Appendix M1
Emerging Preferred Route
- Road Safety Audit

Proposed Blanchardstown to
UCD Core Bus Corridor

Stage 1 Road Safety Audit

Location: Drawing SHT_20_CT_S2_100.1 (A)

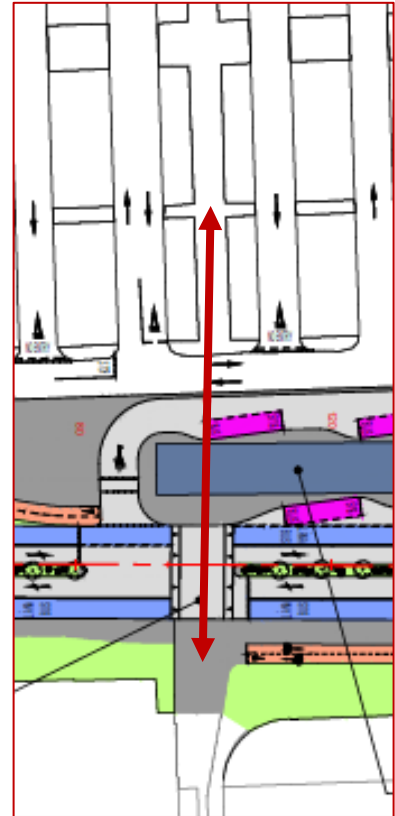
Summary: Absence of measures to cater for likely non-motorised road user (NMU) desire lines between the existing signalised crossing and the NMU route within the car park adjacent to the bus interchange.

No route has been indicated for non-motorised users (NMUs) wishing to travel to/from the proposed bus interchange and the car park and retail area located to the north-west.

It is likely that an NMU desire line will exist between the signalised toucan crossing at the south-western end of the bus interchange and the existing NMU route within the car park area.

Failure to provide an appropriate facility for non-motorised users along this expected desire line could result in unsafe crossings of the bus interchange circulating carriageway leading to vehicular/NMU collisions and serious injuries.

Identify the likely NMU desire lines in the vicinity of the bus interchange and include measures to cater for these.

Location: Drawing SHT_20_CT_S2_100.1 (A)

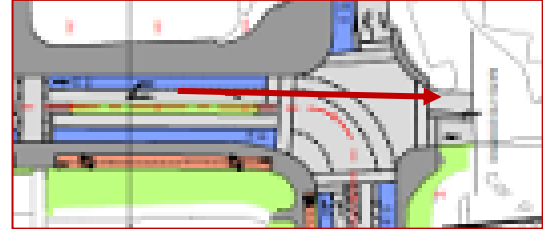
Summary: Lengthy and potentially confusing pedestrian crossing of adjacent carriageways with multiple traffic lanes could result in unsafe crossing manoeuvres by pedestrians leading to collisions between vehicles and pedestrians.

The existing access/egress to the car park located to the north-west of the proposed bus interchange consists of three traffic lanes, one entry and two exit lanes. This existing arrangement exposes crossing pedestrians to vehicular traffic over a lengthy, and relatively complex, crossing.

The proposed layout introduces an additional carriageway, within the proposed bus interchange, adjacent to the existing access/egress. The provision of the proposed bus interchange is likely to increase the number/volume of pedestrians crossing at this location.

There is a concern that crossing pedestrians may be insufficiently aware of the numerous directions from which traffic approaches the two adjacent crossings, possibly resulting in unsafe crossing manoeuvres and collisions between vehicles and pedestrians.

Amend the layout at this location in order to simplify the crossing for non-motorised users, and to reduce the length of the crossing where possible by provision of an additional pedestrian refuge.

Alternatively provide signals at this location to control all movements and reduce the likelihood of conflicts arising.

Location: Drawing SHT_20_CT_S2_100.1 (A)

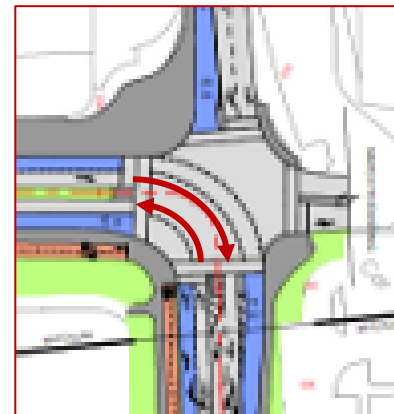
Summary: Unclear lane assignment for straight-ahead north-eastbound vehicles approaching the proposed signalised junction.

It is unclear from the drawings provided whether north-eastbound vehicles approaching the new signalised junction are intended to use the bus lane for proceeding straight-ahead at the signalised junction.

A lack of clarity in this regard could result in unsafe manoeuvres by drivers wishing to proceed straight-ahead into the Crowne Plaza Hotel resulting in side-swipe collisions with buses turning right from the adjacent bus lane leading to material damage.

During the design development clarify the proposed road layout for straight-ahead north-eastbound vehicles approaching the junction.

Location: Drawing SHT_20_CT_S1_1B1.6 (A)

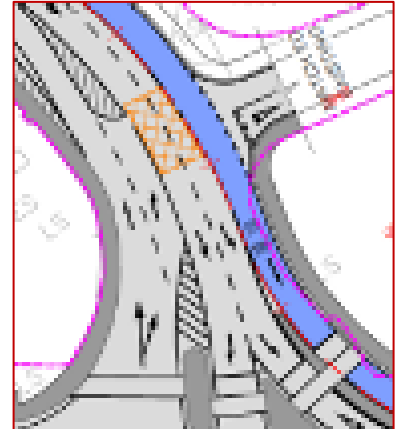
It is proposed to provide a new bus stop on the westbound carriageway of the old N3 near the junction with the overbridge connecting with the James Connolly Memorial Hospital.

Provide a signalised pedestrian crossing of the eastern arm of the signalised junction.

Location: Drawing SHT_20_CT_S1_2A1.100.9 (A)

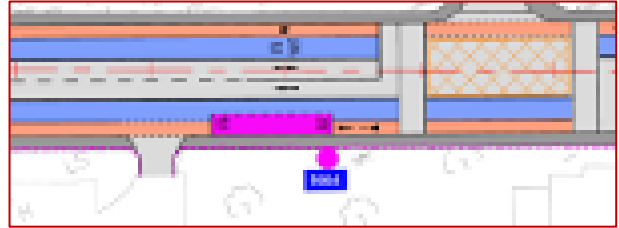
Summary: Stationary bus at bus-stop may impede visibility for drivers exiting from school access

A bus stop is proposed immediately upstream of the exit to a national school (No. 1664), on the southern side of the Navan Road. There is a risk that a stationary bus at bus stop may impede visibility for drivers exiting from the national school, leading to unsafe exiting manoeuvres and possible collisions with through traffic.

During the design development relocate the bus stop to ensure that adequate visibility is available for drivers exiting from the national school.

Project Title		BLANCHARDSTOWN TO THE LIFFEY QUAYS	
Drawing Title		PROPOSED OFF-LINE BUS INTERCHANGE BLANCHARDSTOWN - PREFERRED OPTION SHEET 1 OF 2	
Drawn: RH	Job No: 60540050	Drawing No:	Rev:
Scale: 1:500 @A1	Date: MARCH 2018	SHT_20_CT_S2_100.1	A

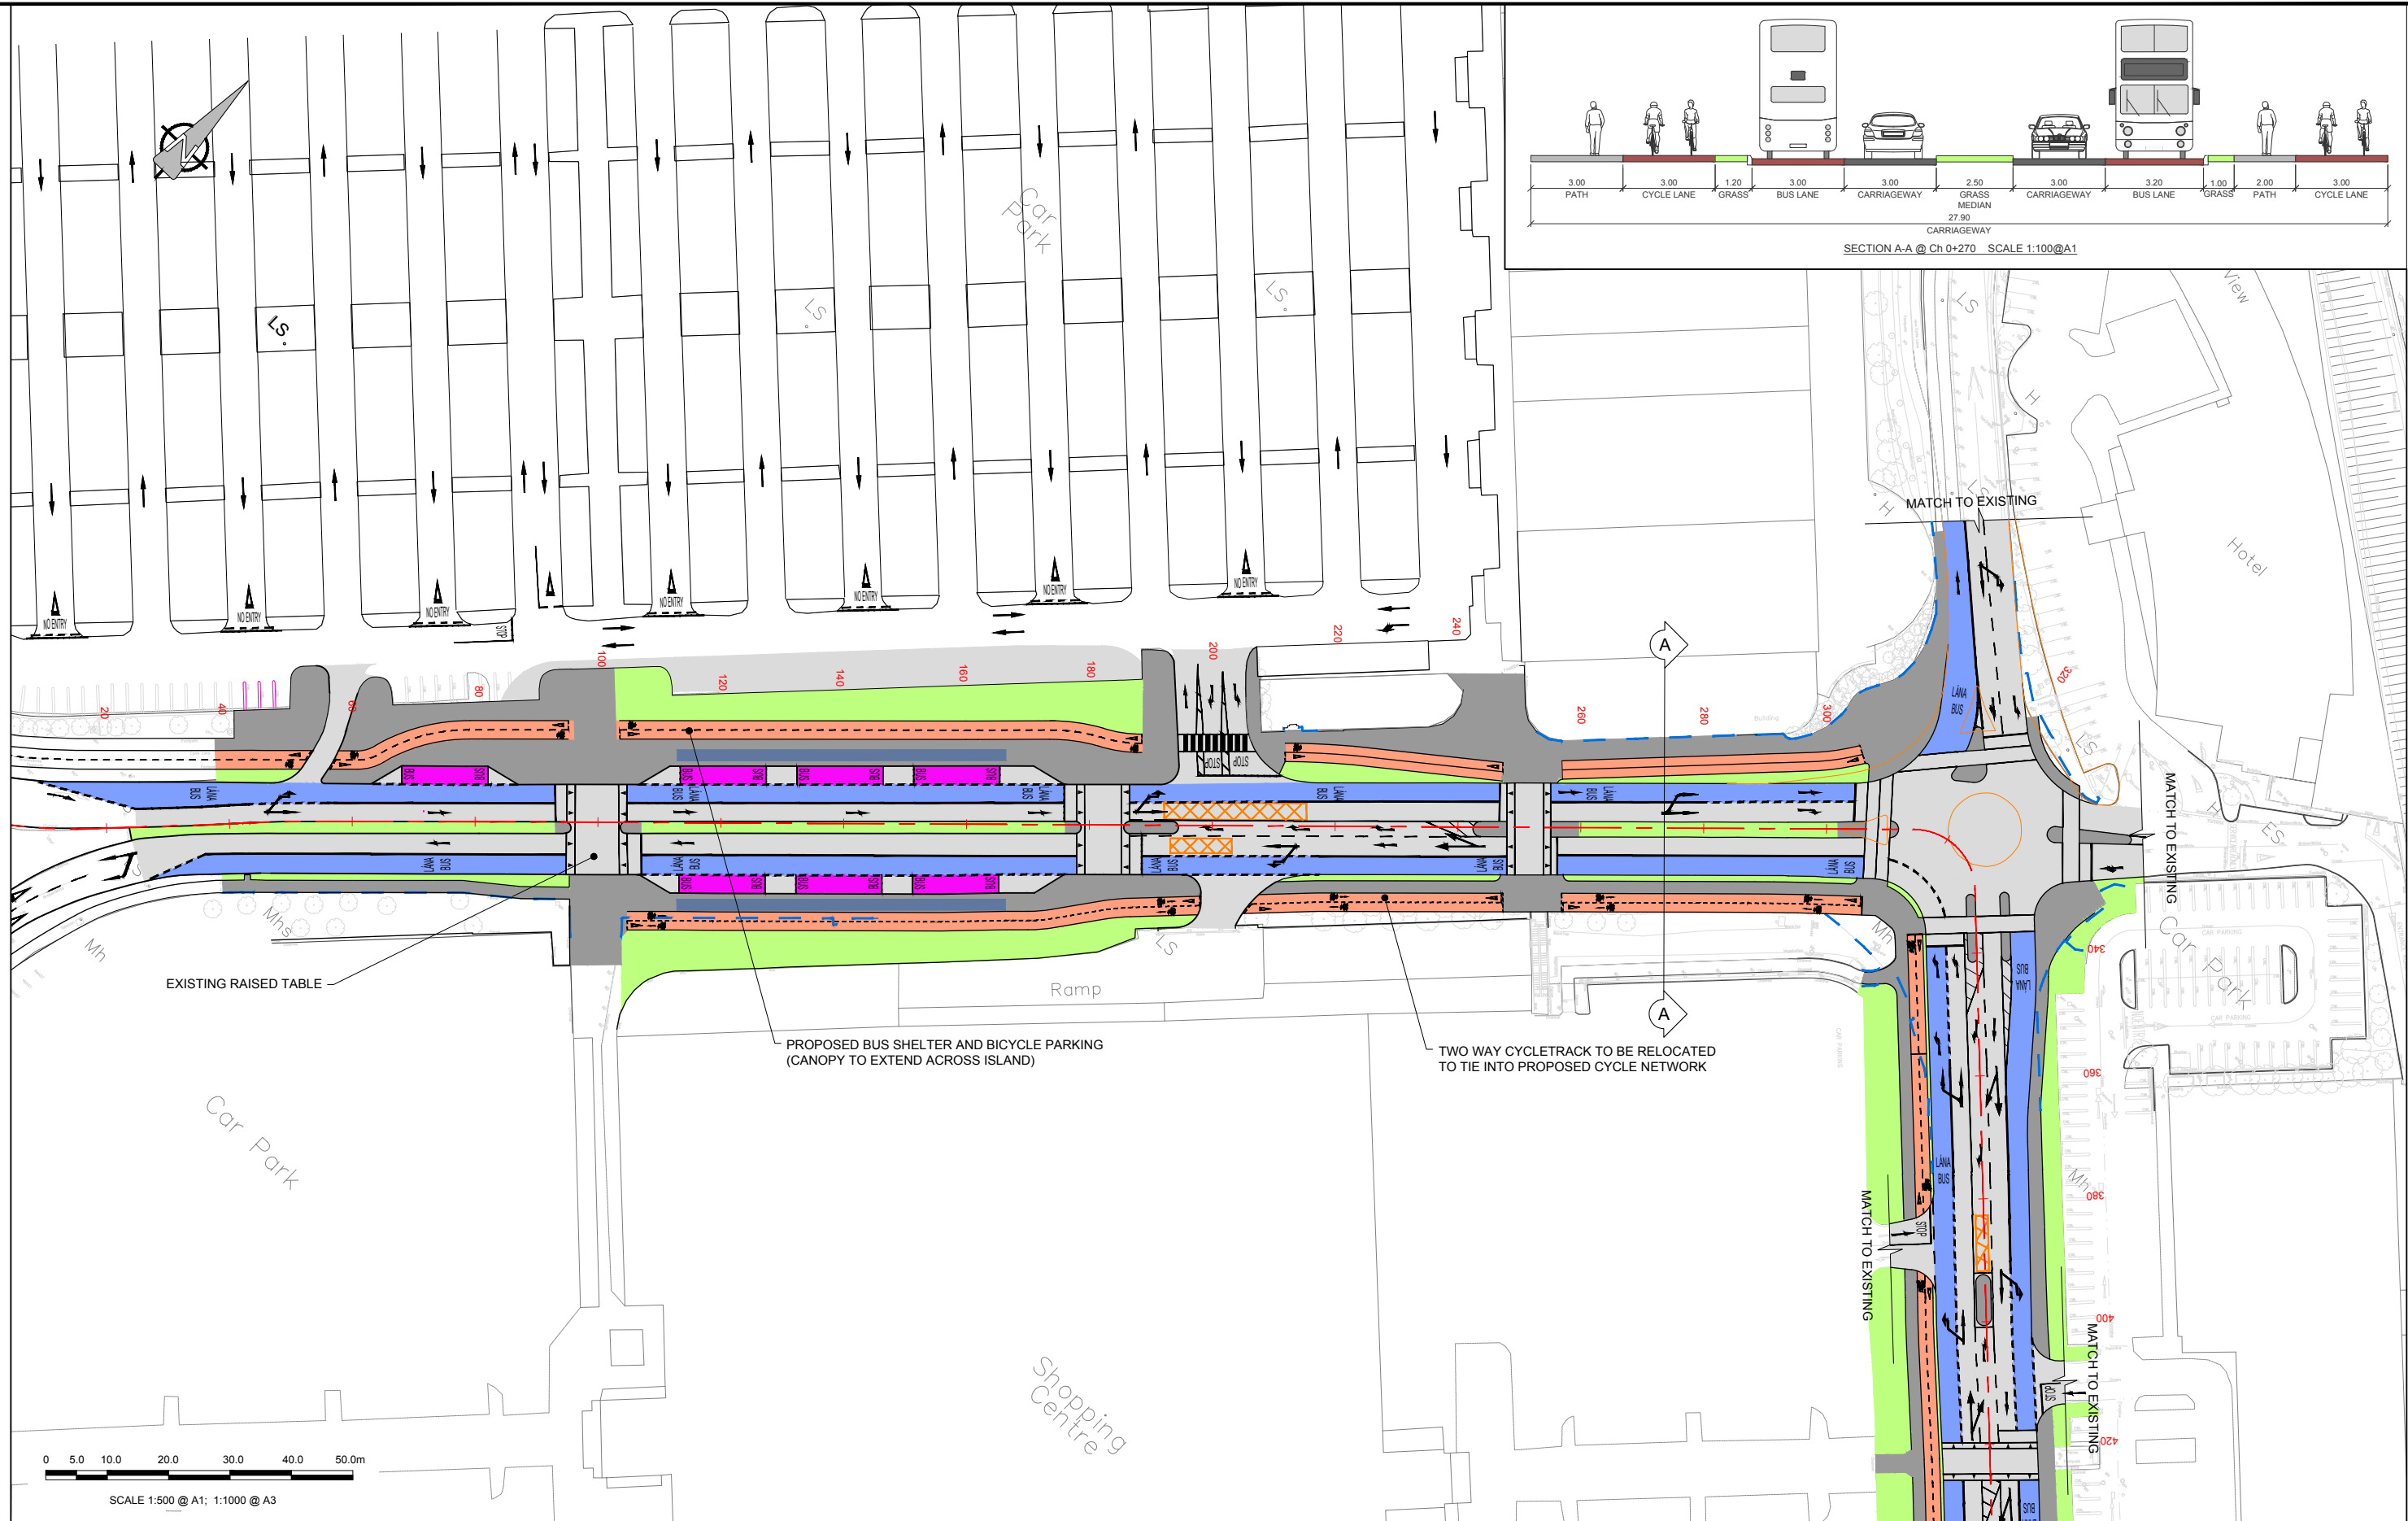
Summary: Lack of clarity on which road users have priority at the pedestrian/cyclist crossing of the exit from the bus interchange area.

A two-way cycle track is indicated along the road edge to the south-west of the proposed bus interchange. The cycle provision continues on the other side of the road to the north-east of the signalised crossing, and it is presumed that cyclists are intended to cross the exit from the bus interchange in order to access the signalised crossing in order to access the cycle facilities on the other side of the road.

No measures have been indicated to facilitate cyclists crossing the exit from the bus interchange, which could result in confusion as to whether buses or cyclists have priority at this location.

A lack of clarity on which road users have priority at this location could lead to both drivers and cyclists assuming they have priority, leading to collisions and serious injuries.

During the design development clarify the priority between buses and cyclists at this intersection and put in place measures to ensure that all road users clearly understand the relative priority (e.g. provide a raised-table crossing catering for both cyclist and pedestrians).

Project Title		UCD TO St. STEPHENS GREEN	
Drawing Title		UCD TO St. STEPHENS GREEN EMERGING PREFERRED SCHEME SHEET 1 OF 13	
Drawn: RH	Job No: 60540050	Drawing No:	Rev:
Scale: 1:500 @A1	Date: MARCH 2018	SHT_20_CT_S3_1A1.300.1	A

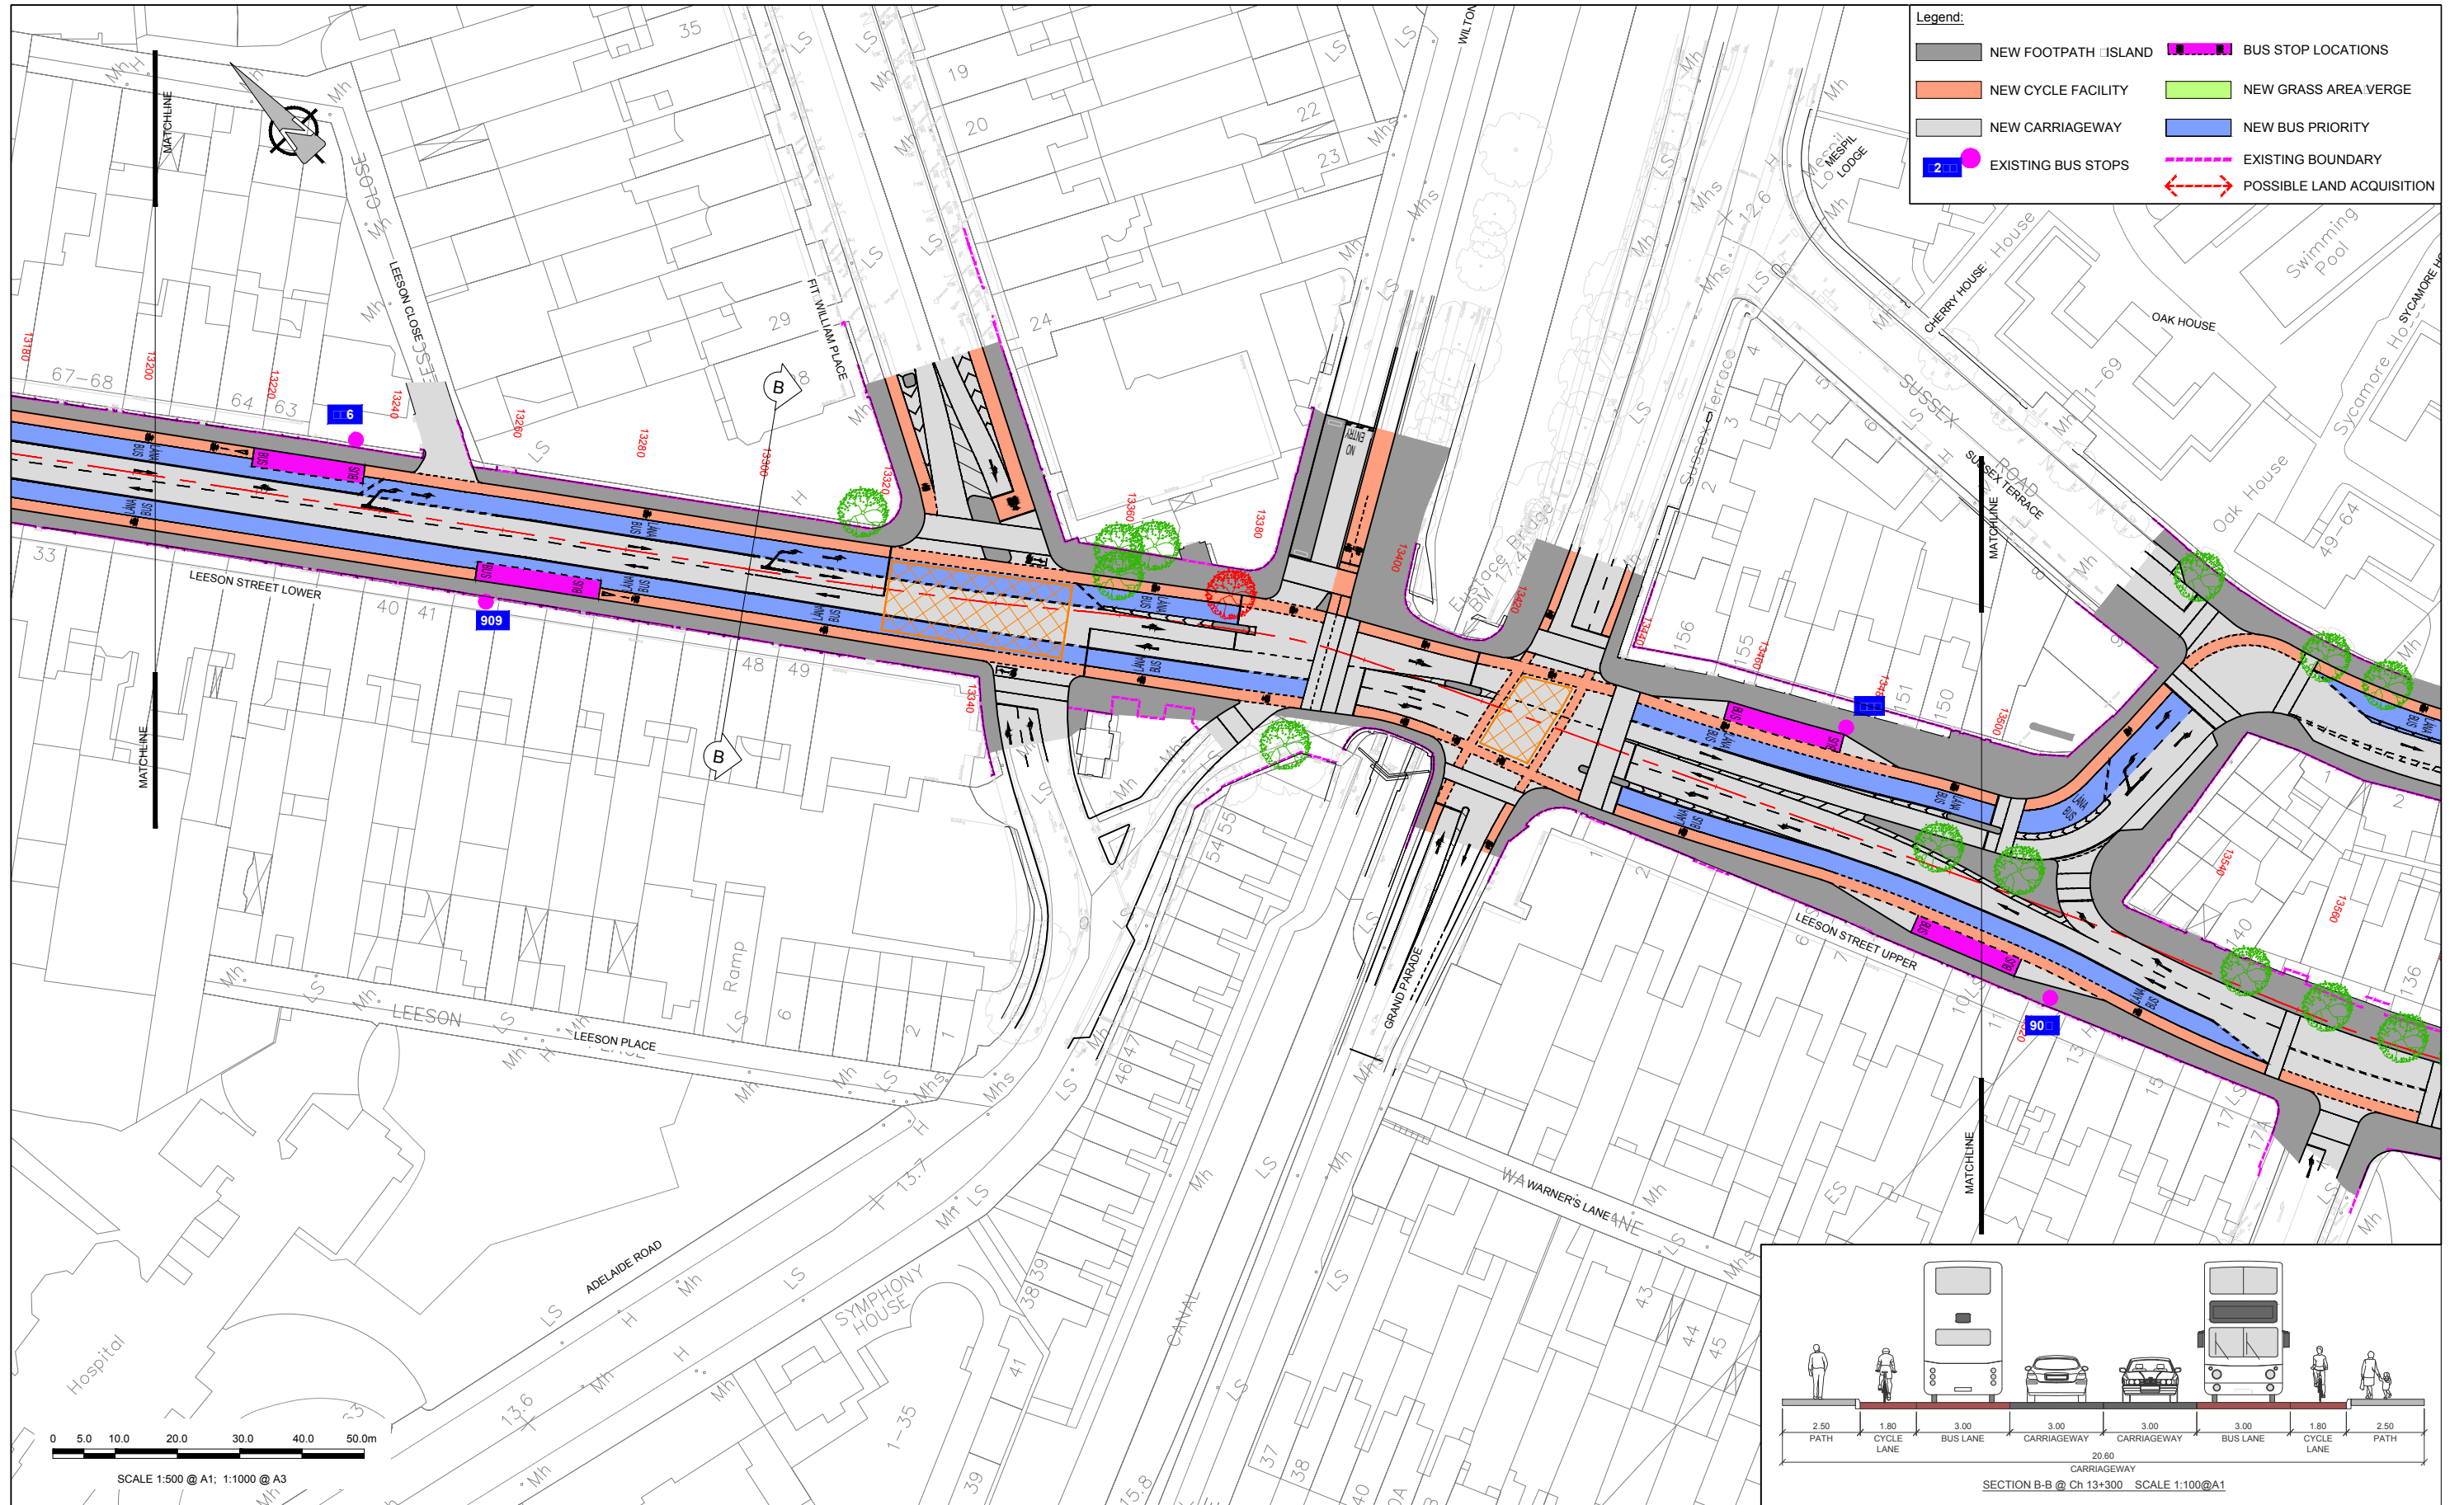
Summary: Unclear how bus lane will tie into the existing road layout.

Provide measures to allow cyclists to continue on Leeson St. from the western arm of the junction.

Revise the proposed layout to allow all vehicles to turn left from Leeson St onto Earlsfort Terrace.
